DEVELOPMENT REVIEW COMMITTEE (DRC) COMMENT REPORT

Project Name: Maroone Ford, LLC / SC 1413 FED

Case Number: R15005
Request: Site Plan Level II Review: 39,000sf Retail Building

Location: 1413 N. Federal Highway
Zoning: Boulevard Business District (B-1)
Land Use: Commercial

SHEET No.
SP1

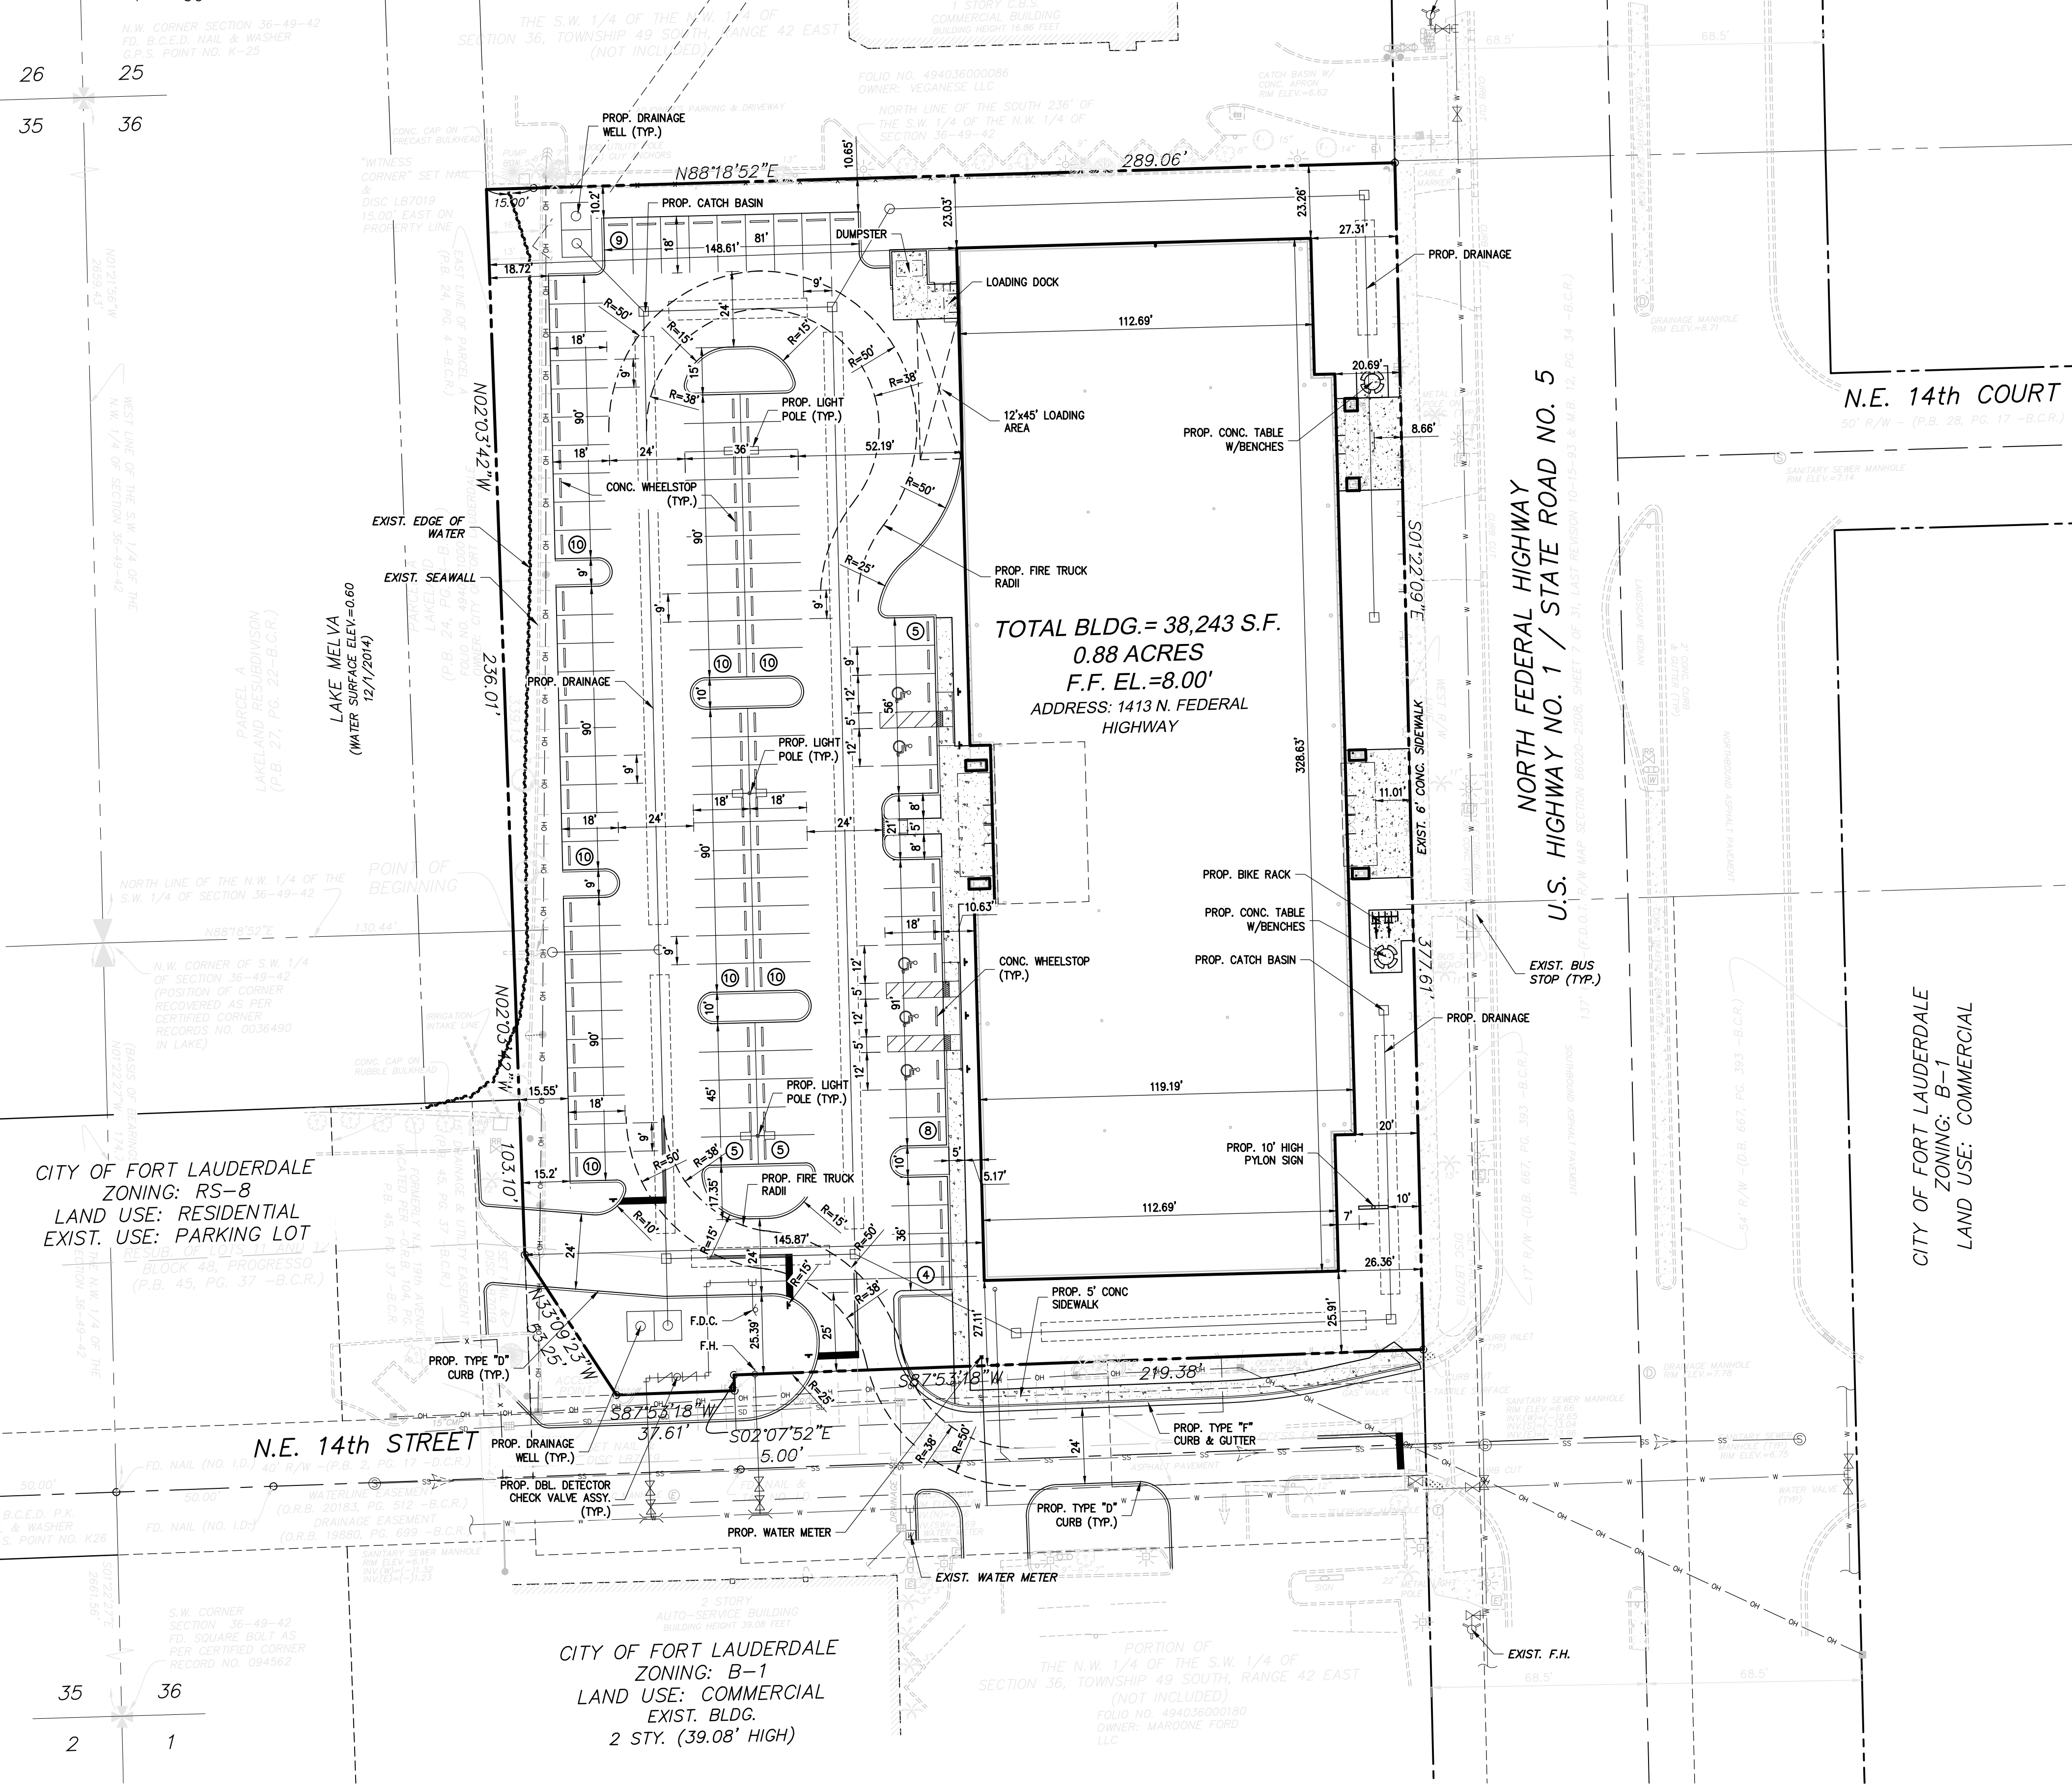
1. Provide mitigation calculations.
2. Shift the southern light pole in parking area further north to avoid tree conflicts.
3. Consider location of landscaping along west building wall in relation to wall pack lighting.

7. Increase fern and implement Florida Friendly Landscaping™ in areas where small strips of grass are proposed.
8. Extend landscape areas at the west side of dumpster enclosure to provide planting space for required hedge.

9. Illustrate the required vs. provided pervious area for the vehicular use area calculation.
10. Clarify what the limit of work line is and where the edge of water line is – both are necessary for inspection purposes.

11. Shift the proposed drainage well on NW parking as it is located in a required tree area.
12. Provide canopy trees (instead of palms) in landscaped islands at west side of building.

13. Provide a 5' buffer yard wall at west parking perimeter and maintain continuous screen as proposed to provide adequate neighborhood compatibility.
14. Consider closing the SW driveway.

- b. Provide a roof plan showing all rooftop mechanical equipment;
 - c. Provide safe pedestrian connections between the parking lot and building. Show the connections on the site plan;

- 7) Pursuant to ULDR Sec. 47-25.3.A.3.D, Bufferyard requirements, a ten-foot landscape strip shall be required to be located along all property lines that are adjacent to residential property. A minimum five-foot high wall shall be required on the non-residential side. The site plan depicts access from this site to a parking lot on a residentially zoned parcel to the west of the site. Discuss alternative options for that access with City staff at the DRC meeting.

8. Provide on the site plan a garbage truck turning radii for City review. Drive aisle width and design configuration must allow for safe and efficient maneuverability on-site and off-site. Indicate how truck will circulate to/from/within property.

4. Provide justification for providing access to private property through the site.
5. Residential (zoned RS-8) is adjacent to the lot – a bufferyard is necessary. The bufferyard is required to be a minimum of 10 feet in depth per Section 47-25.3 item 3D. Parking is not allowed within the bufferyard per Section 47-20.4.
